Item Name: Floor Provisions

Work Order ID: 101065
Parent Item: D350-689-013
Parent Item Name: Floor Provisions

TO AMEND INSTALLATION INSTRUCTIONS IIN-D350-689 REV. B
AND INSTRUCTIONS FOR CONTINUED AIRWORTHINESS ICA-D350-689 REV. 1

B	CHANGES TO -013 KIT INSTALLATION. REF: CIR12-12.	MB	12.11.09
A	NEW ISSUE	MB	11.12.22
REV.	DESCRIPTION	BY	DATE
DESIGN			
DRAWN			
CHECKED			
MFG. APPR.	N/A		
APPROVED			
DE APPR.			
DATE	12.11.09		
DART AEROSPACE LTD HAWKESBURY, ONTARIO, CANADA		REV. B SHEET 1 OF 6	
DRAWING NO. DSI 9588		TITLE INSTALLATION CHANGE	
COPYRIGHT © 2011 BY DART AEROSPACE LTD THIS DOCUMENT IS PRIVATE AND CONFIDENTIAL AND IS SUPPLIED ON THE EXPRESS CONDITION THAT IT IS NOT TO BE USED FOR ANY PURPOSE OR COPIED OR COMMUNICATED TO ANY OTHER PERSON WITHOUT WRITTEN PERMISSION FROM DART AEROSPACE LTD.		NTS

FIGURE 1: UPDATES TO CROSS SECTIONS F-F AND M-M

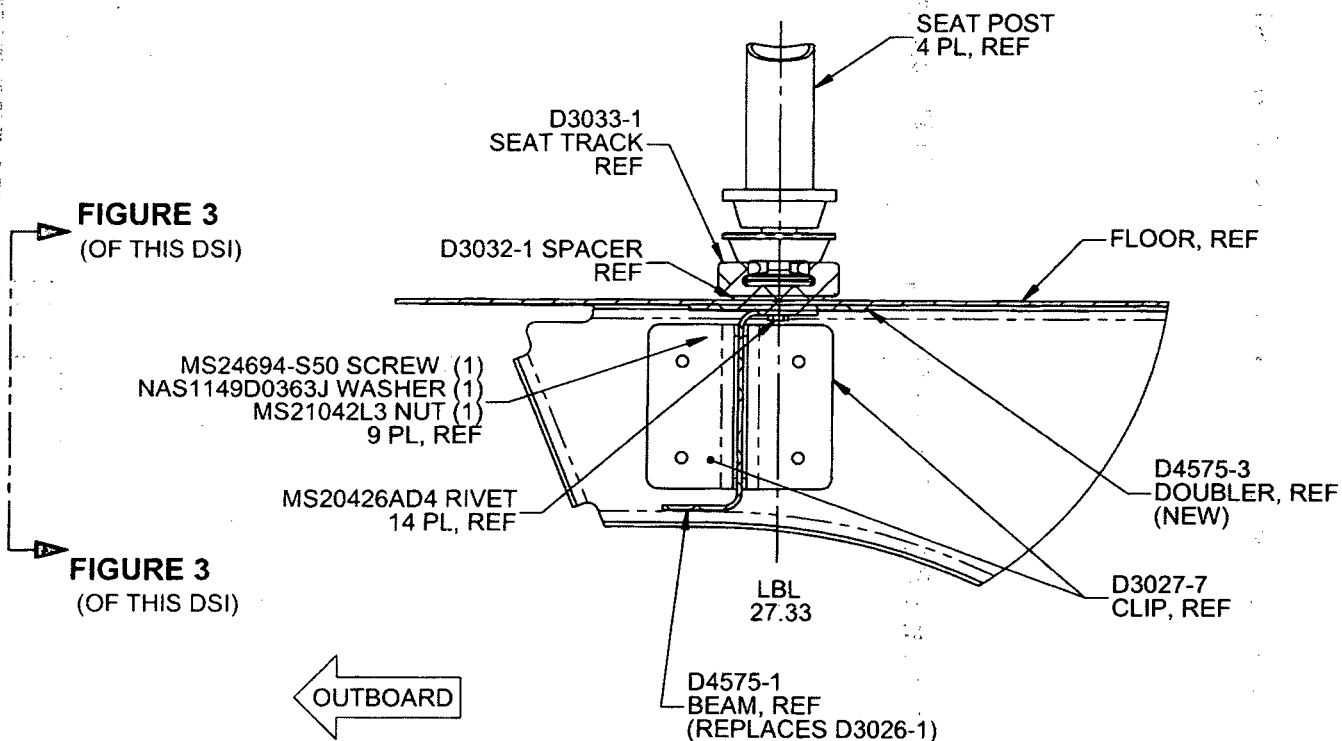
If there is an existing stringer at LBL 27.33, it will need to be removed from that location. Locate D4575-1 Beam, D4575-3 Doubler, and D3032-1 Spacer as shown in Figure 1 of this Service Instruction. Transfer drill existing holes from the aircraft floor to the D4575-1 Beam, D4575-3 Doubler, and D3032-1 Spacer. Ensure 1.0" to 1.5" rivet pitch and add additional holes if required. If there is no existing stringer, locate D4575-1 Beam, D4575-3 Doubler, and D3032-1 Spacer as shown in Figure 1 of this Service Instruction and drill Ø0.128" holes on a 1.0" to 1.5" pitch.

Counter sink holes in the D3032-1 Spacer for MS20426AD4 rivets. Install D4575-1 Beam, D4575-3 Doubler, and D3032-1 Spacer to floor using MS20426AD4 rivets.

FIGURE 2: UPDATES TO FIGURE 21 (IIN-D350-689) AND 25-21 (ICA-D350-689)

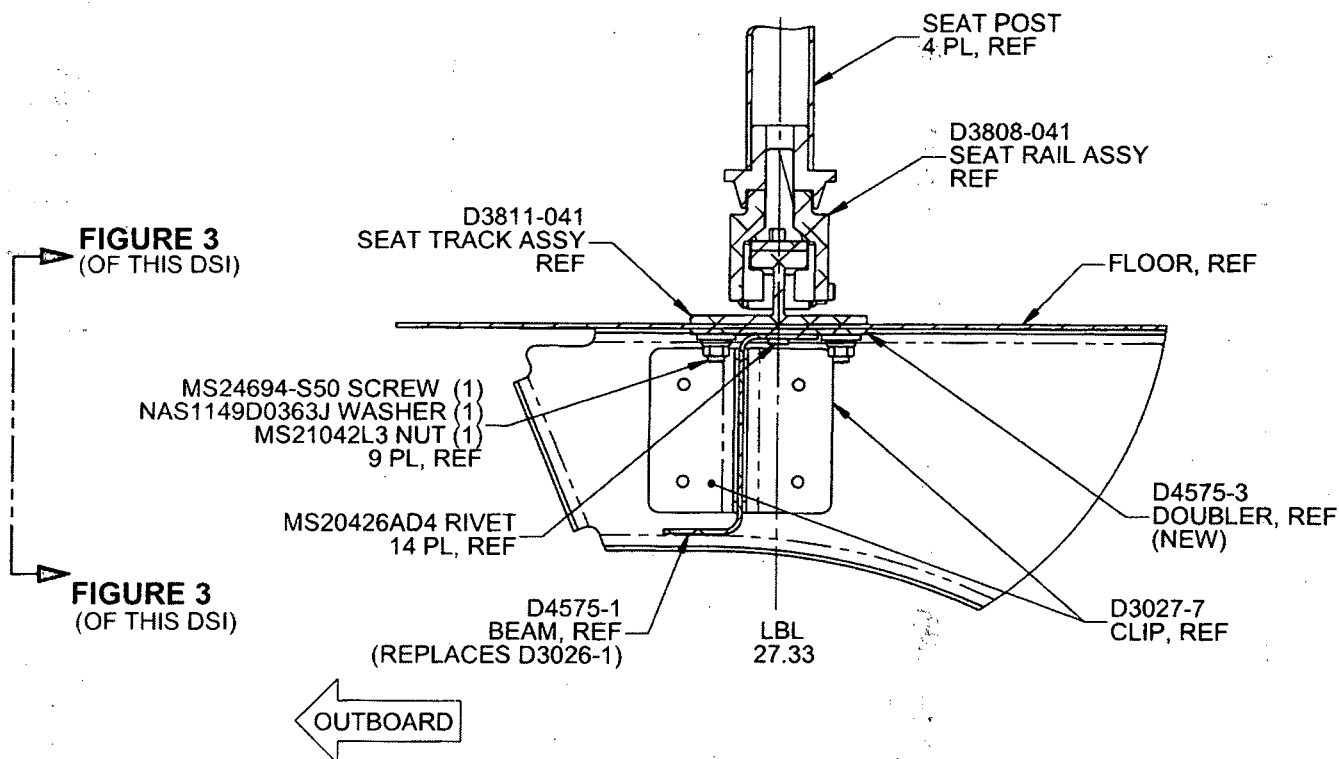
If there is an existing stringer at LBL 27.33, it will need to be removed from that location. Locate D4575-1 Beam and D4575-3 Doubler as shown in Figure 2 of this Service Instruction. Transfer drill existing holes from the aircraft floor to the D4575-1 Beam and D4575-3 Doubler. Ensure 1.0" to 1.5" rivet pitch and add additional holes if required. If there is no existing stringer, locate D4575-1 Beam and D4575-3 Doubler as shown in Figure 1 of this Service Instruction and drill Ø0.128" holes on a 1.0" to 1.5" pitch.

Attach D4575-1 Beam and D4575-3 Doubler to floor using qty (14) MS20426AD4 rivets.

FIGURE 3: RELIEFS ON D4575-1/-3
(ONLY D4575-1/-3 SHOWN FOR CLARITY)
VIEW LOOKING INBOARD

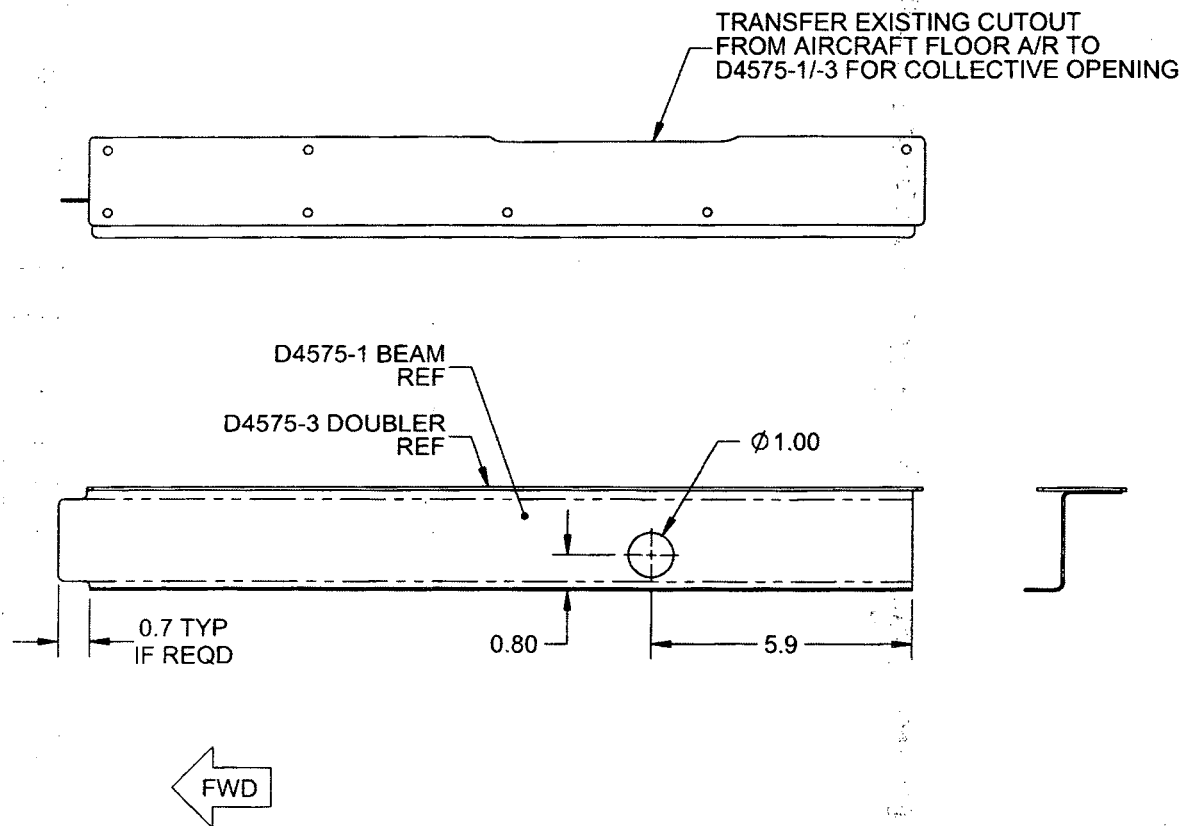
Note: Drill a Ø1.00" (Ø25.4 mm) hole in the D4575-1 Beam to clear extension tube of collective and cutout as required for clearance of collective opening and fwd bulkhead as shown in Figure 3 of this Service Instruction.

Note: Drill a Ø1.00" (Ø25.4 mm) hole in the D4575-1 Beam to clear extension tube of collective and cutout as required for clearance of collective opening and fwd bulkhead as shown in Figure 3 of this Service Instruction.
